DESIGN EVOLUTION DOCUMENT

KINGFISHER GROVE 3 MILE CROSS
BERKSHIRE
RG7 1LZ

Original RM Submission Layout – RM Planning Site Layout Plans

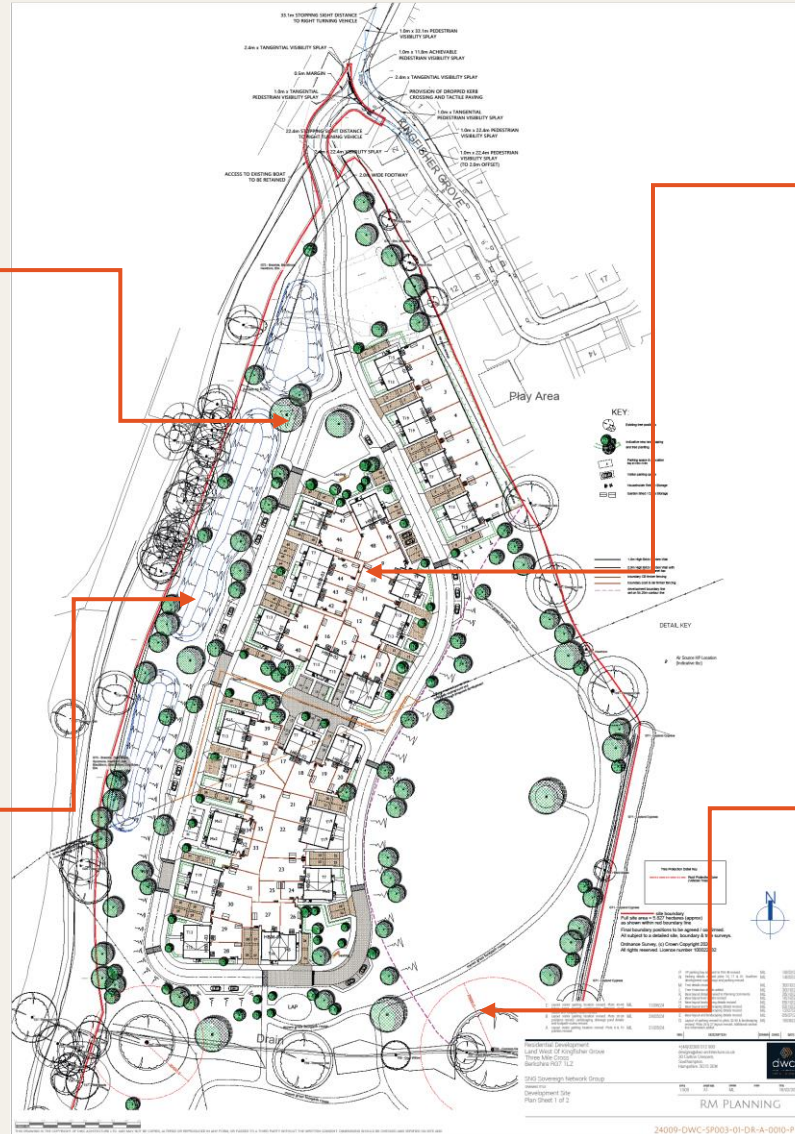
Proposed redesigned drainage and level strategy over the whole development site to include landscape design features. See consultants detailed designs and specifications.

Indicative FFL revised. Associated retaining and boundary wall levels are shown for information purposes only and are subject to a final detailed design and agreement as a Condition. Retaining and boundary walls will be topped with close boarded fencing to produce a min. 1.8m high boundary.

Full notice has been taken of all the Veteran Tree locations within the development and no development of any type intrudes into the buffer zones relating to each tree location.

Revised Submission Layout Plans

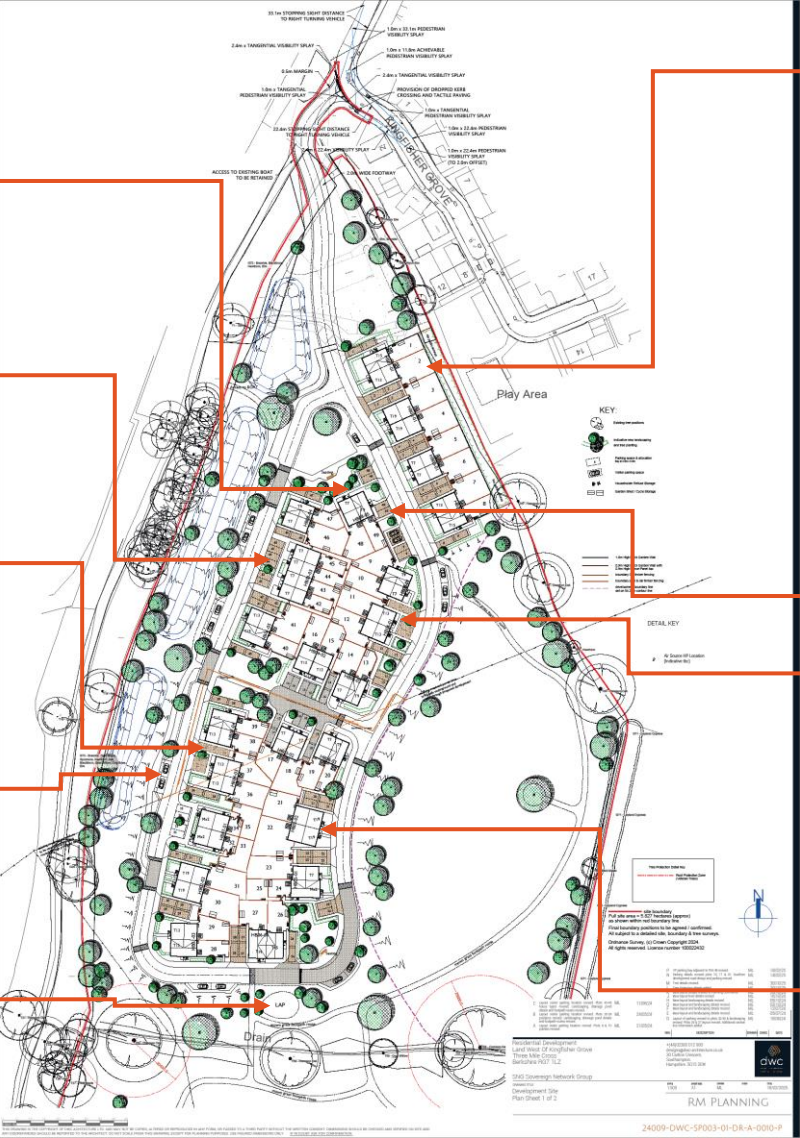
Plots 48-49 repositioned to north to allow for greater separation rear to rear distances to plot 9. All associated parking and landscaping repositioned.

Plots 42-45 units repositioned to allow for frontage parking to be relocated behind 2m wide footpath crossing.

Plot 37 parking relocated to allow for landscaping details.

Visitor parking bays introduced on 'western road' adjacent to redesigned and detailed drainage ponds opposite plots 36 & 37.

LAP repositioned to enhance security 'overlooking surveillance' with redesigned linking paths and POS access routes and landscaping

Plots 1-8 All boundary details revised. Parking adj.to Plot 8 layout revised to laybys

Half-height brick walls with fence panel tops added on plot boundaries that interface with the public realm. A full 1.8 m high brick boundary wall is to be provided to the rear of plots 1-8.

The maintenance strip to the rear of 1-8 is to be enclosed at each end by post and rail fences possibly with stock fencing attached, with a lockable gate

Visitor parking space north of plot 49 repositioned due to visibility.

Plots 10-11 Plot parking revised to allow for landscaping details.

Road design, width and structure revised fronting Plots 21 to 28. All turning heads removed and new linking curve provided to form 'loop road'. redesigned, plot parking redesigned and new locations of visitor parking spaces provided (all layby)

DESIGN QUE FROM SURROUNDING SITES

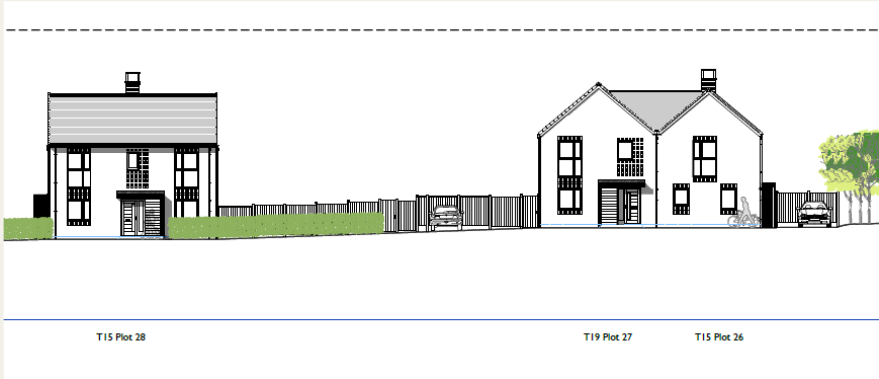
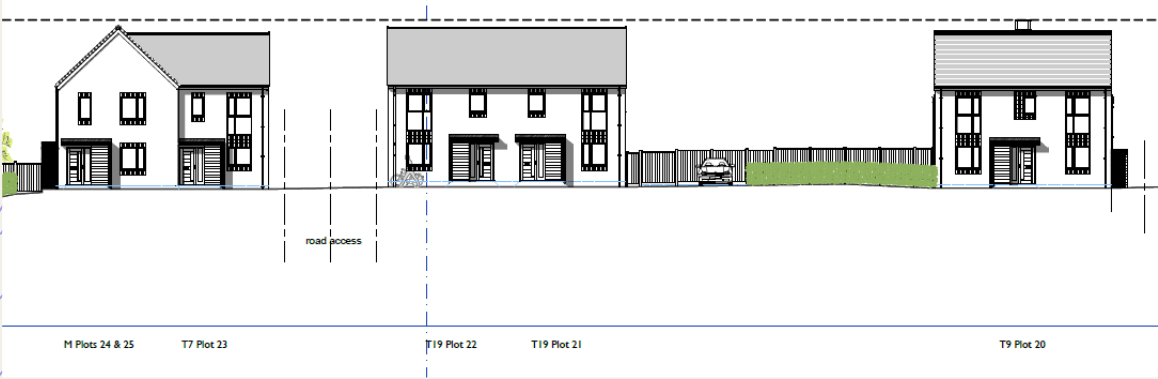
The grey detail brick wrap around elements seems an odd element that is advised to be removed. The design guidance isn't considered the best example to reflect the character of the area. It may be worth considering incorporating the grey bricks on a more scattered basis (similar to the protruding grey brick feature elements proposed) to add texture:

It is agreed the articulation of the Victorian grey buildings has not translated well with the wrapping.

We are agreeable to work with the brick pallet in a cleaner simpler and more consistent brick detailing. Amend to using a red-grey multi-brick. Using a simple brick detailing palate

To include

1. Chimneys to 10 plots highlighting feature and secondary buildings
2. Projecting brickwork
3. Simple head and cill detailing for 3rd tier properties
